ON-SITE SEWAGE DISPOSAL SYSTEM
HOWARD COUNTY HEALTH DEPARTMENT
BUREAU OF ENVIRONMENTAL HEALTH

03-340600

SUBDIVISION: Frothingham Property / HAPPY HILLS FARM LOT NUMBER: 3

ADDRESS: 813 Route 32 PROPERTY OWNER: James Frothingham

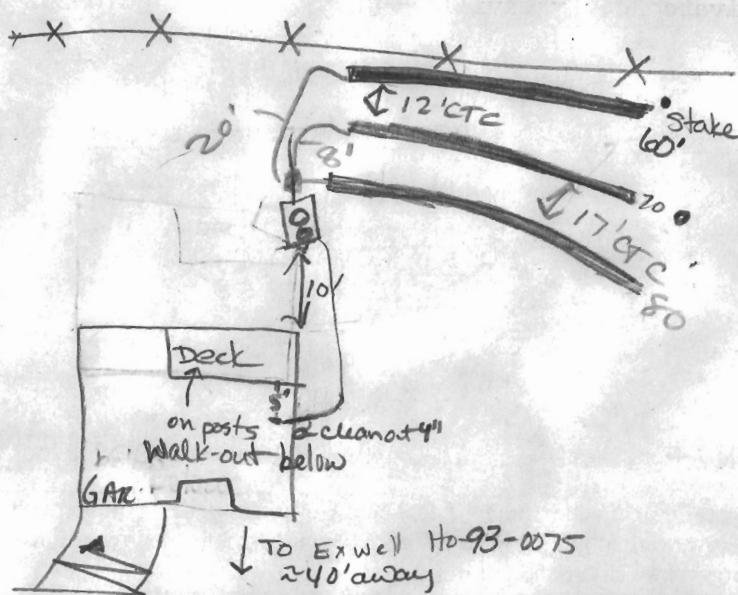
PRE-CONSTRUCTION 8/29/03 SDA NOT STAKED OUT; SYSTEM LAYOUT REVIEWED; INSTALLER TO WAIT FOR SDA STAKEOUT BEFORE STARTING MR
 INSTALLATION 9/2/03 AM. 60' trenching per spec. S.T. location per spec. OK TO CONTINUE TRENCHES 12' CTC. KN/KB PM. OK TO COVER ALL WORK (KN/KB)

FOUNDATION CERTIFICATION
LOT 3
HAPPY HILLS FARM
3rd ELECTION DISTRICT HOWARD COUNTY, MD.
PLATBOOK NO. MRD 16004

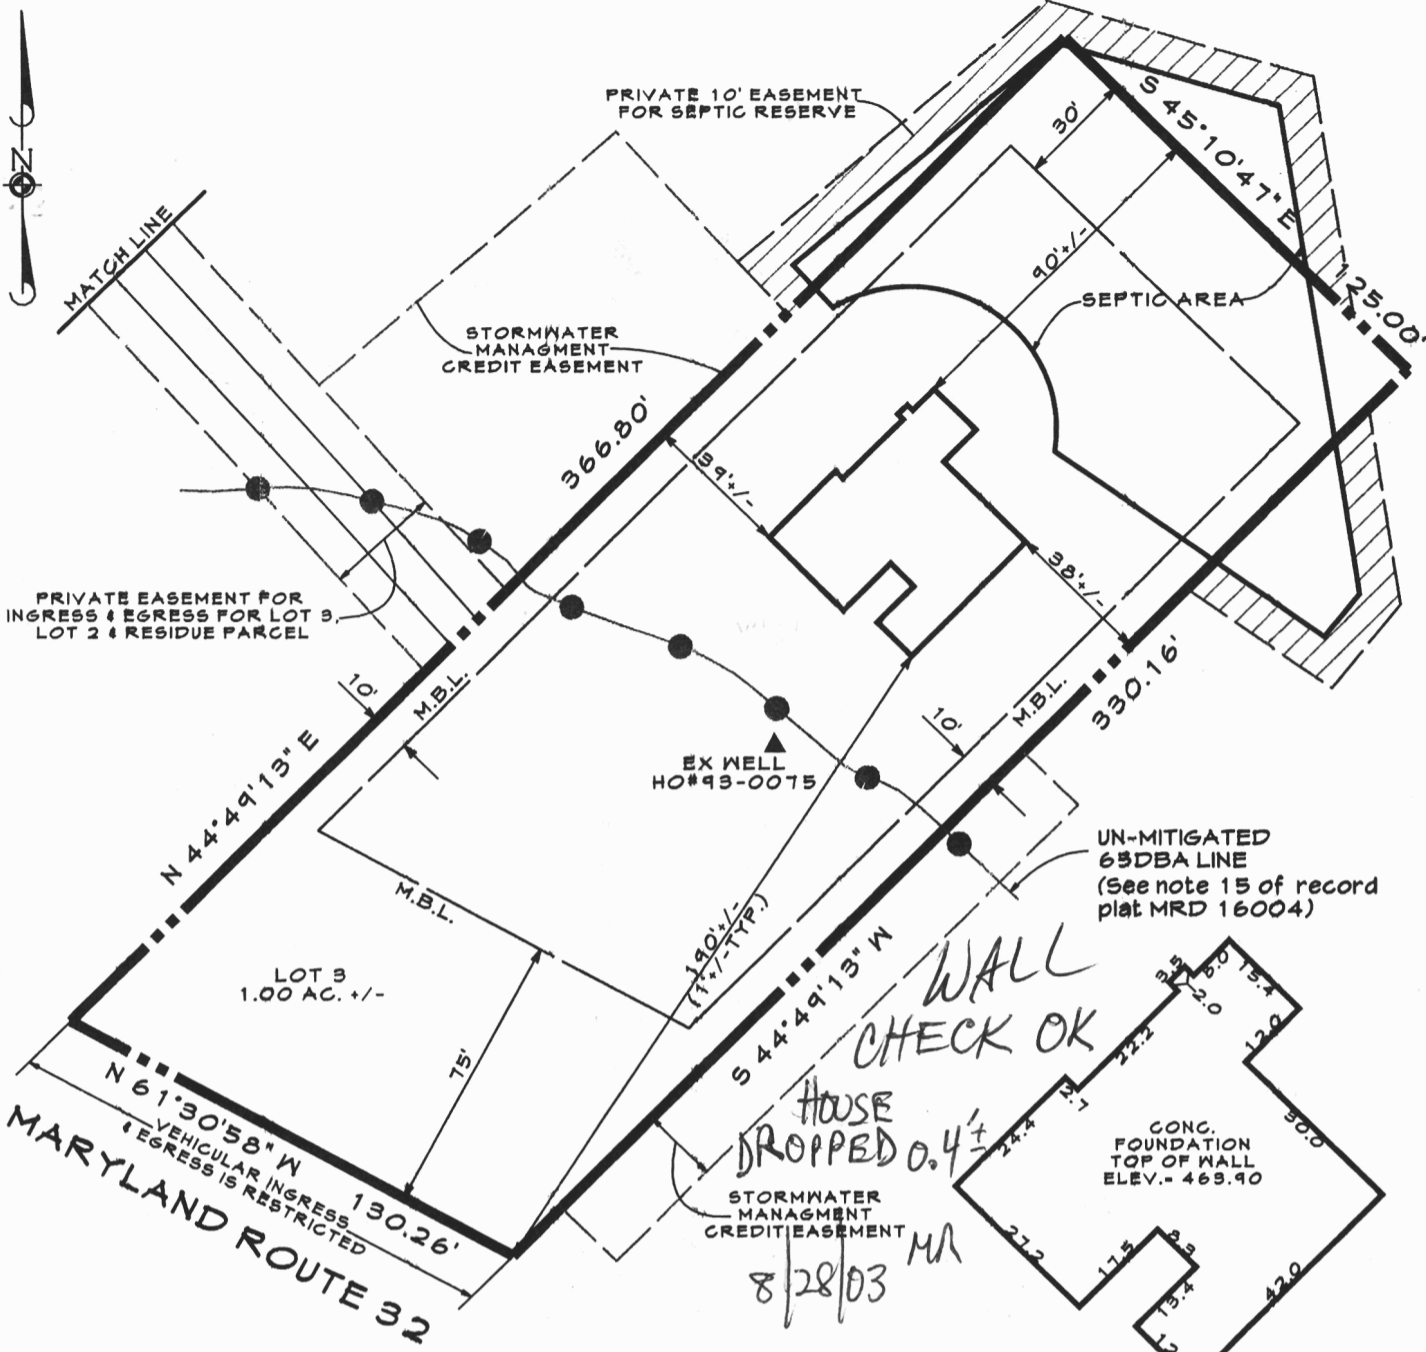
WALL CHECK OK

HOUSE DROPPED 0.4' ±
8/28/03 MR
